SHEET SIZE= C	DRAWN BY: F.S.B.	PART NUMBER or STYLE:
SCALE = 1"=1'	DATE DRAWN:	C10 4ft Stair Section
STANDARD TOLERANCES:	2/10/2015	Quote requested by:
.00 ±.01 FRACTIONS:	LDC:	Z:\Aluminum\Westbury\C10
.000 ±.005 ±.1"	Tuscany\Section\Stair	
ANG. ±.5° ±.1°	FIRST USED ON:	PART NAME:
	DRAFT:	C10 Tuscany
	2014-1001-2F	SHEET REV.
		of B

SHEET SIZE= C	DRAWN BY: F.S.B.	PART NUMBER or STYLE:
SCALE = 1"=1'	DATE DRAWN: 2/11/2015	C10 6ft Stair Section
STANDARD TOLERANCES: .00 ±.01 FRACTIONS: .000 ±.005 ±.1" ANG. ±.5°	LOC: Z:\Aluminum\Westbury\C10 Tuscany\Section\Stair	Quote requested by:
FIRST USED ON:	DRAFT: 20141001-4F	PART NAME: C10 Tuscany
		SHEET REV. of B

FINISH:	SHEET SIZE= C	DRAWN BY: wjm	PART NUMBER:
	SCALE = none	DATE DRAWN: 12-16-2009	
DSI Digger Specialties, Inc. 3446 US 6 EAST Bremen, IN 46506	STANDARD TOLERANCE: .00 ±.01 FRACTIONS: .000 ±.005 ±.1" ANG. ±.5° ±TB	FILE LOC: Z:\Aluminum\Westbury\C30 Riviera\C30	STYLE: Riviera
	DRAFT: 20101025-4	Riviera\Section\Stair	FILE NAME: C30 8ft Stair Section
			REV. D

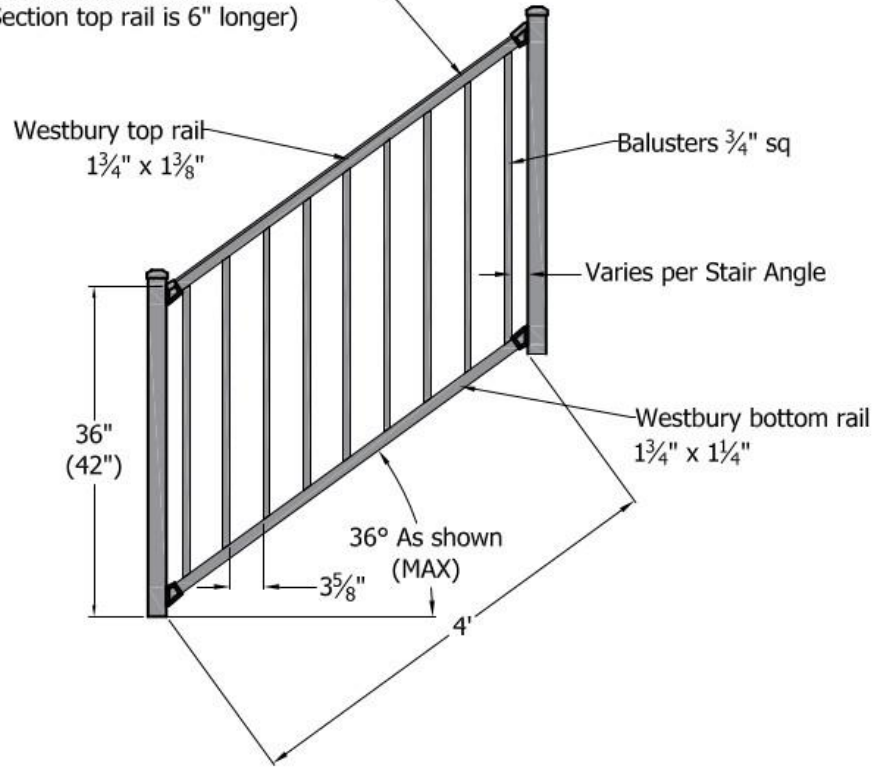
PART NUMBER:	
REV.	LDC.	REVISION	DATE
A		RELEASE PENDING APPROVAL	
B		Baluster spacing 3.625. Increased hole size to accommodate 38" stairs.	2/11/15

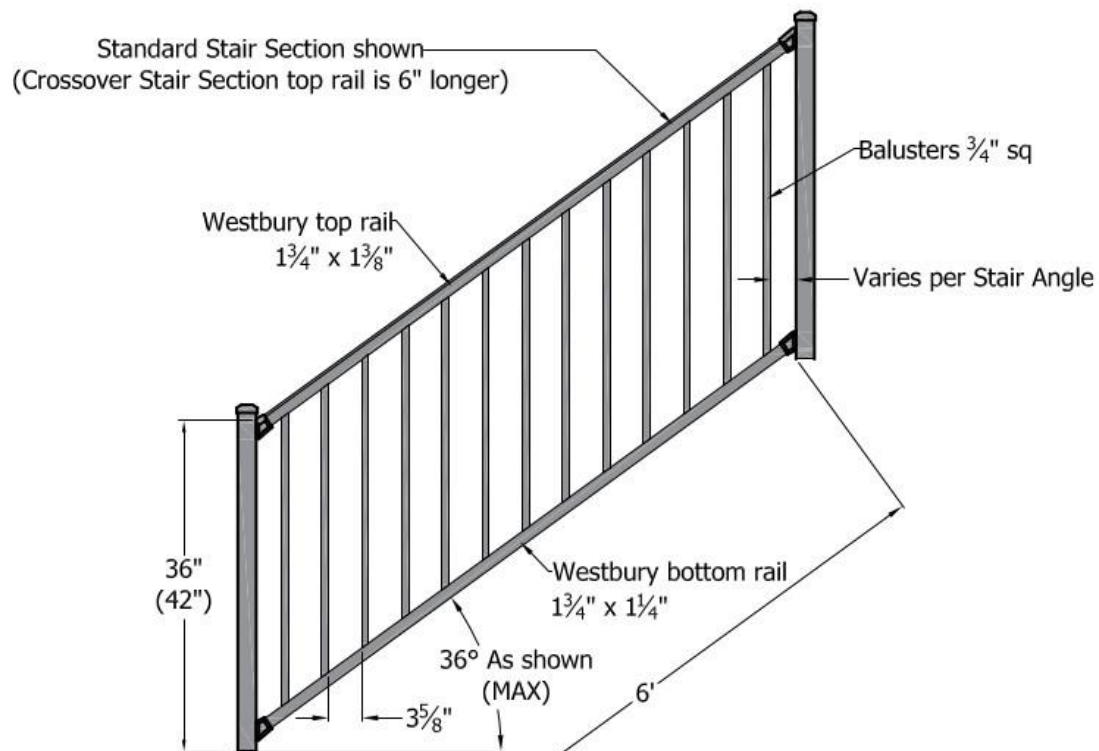
REV.	LDC.	REVISION	PART NUMBER:	DATE
A		RELEASE PENDING APPROVAL		
B		Baluster spacing 3.625. Increased hole size to accommodate 38" stairs.		2/11/15

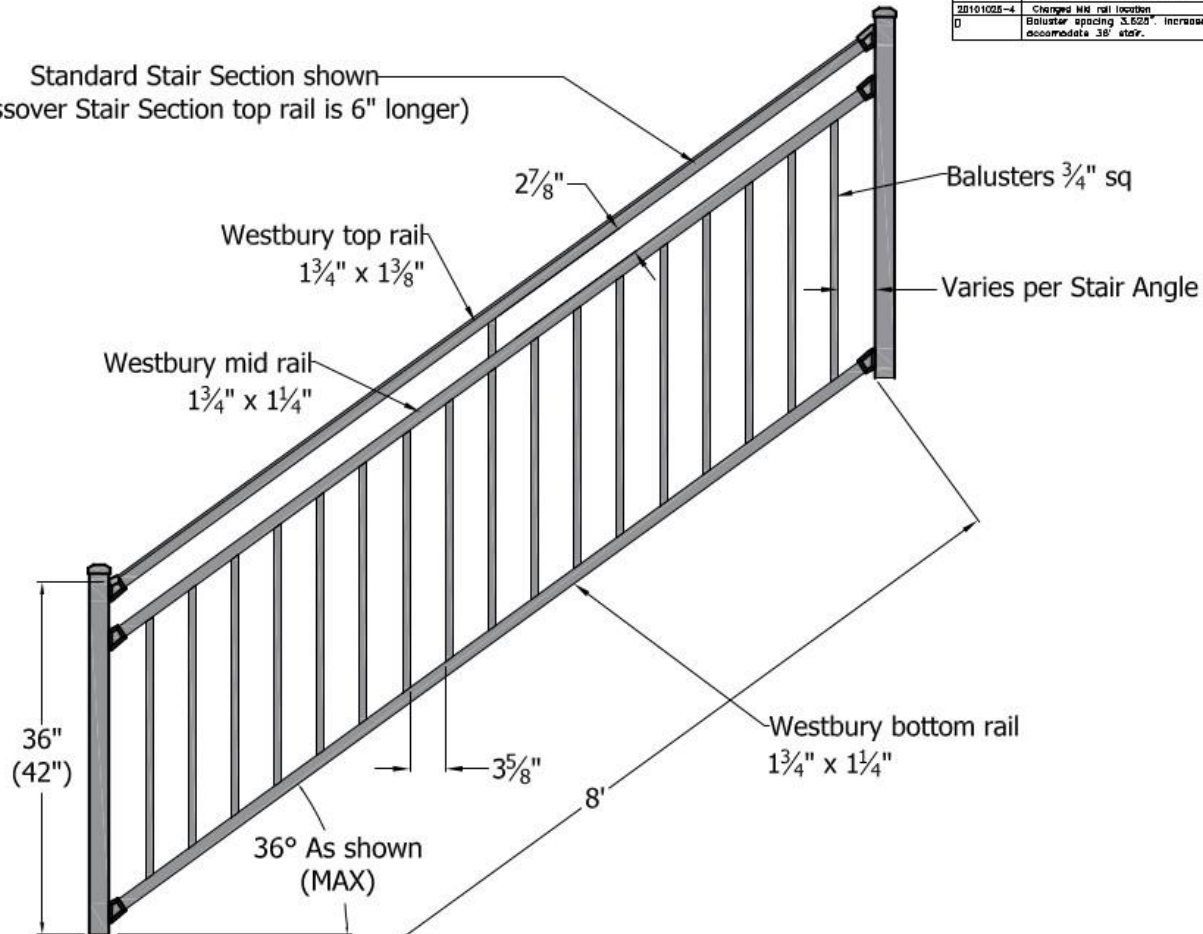
REV	REVISION	DATE
20091223-2	Added center support	12-23-09
20100826-3	made 3' 6" 8m vertical LO aligned	8-26-10
20101025-4	Changed MM rail location	10-28-10
0	Baluster spacing 3.625" increased hole size to accommodate 36' stair.	2/13/15
